Access Compliance Report Public Rights-of-Way (Curb Ramps)

Main Street: N/A Cross Street: ANTONIO_PKWY Location: N

ADA ID: RPRK211202124029 Ramp Type: Type 7 - Directional 2 Initial Pass/Fail: Fail Overall Compliance: No Severity Score: 15

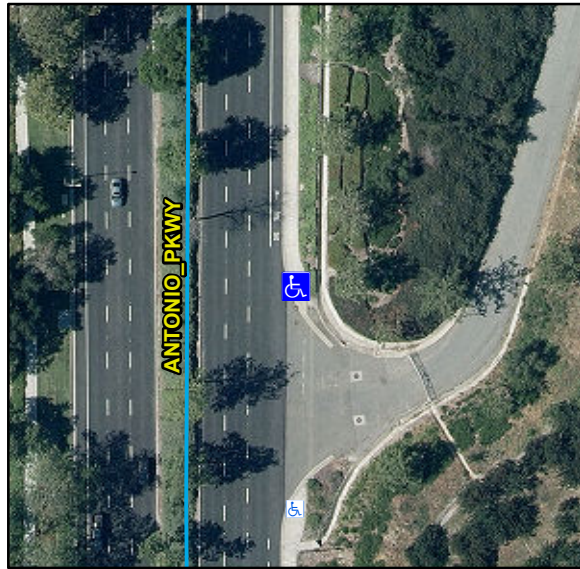
R204.3, R304.5.3, STD 1115

Remove & Replace Entire Ramp.
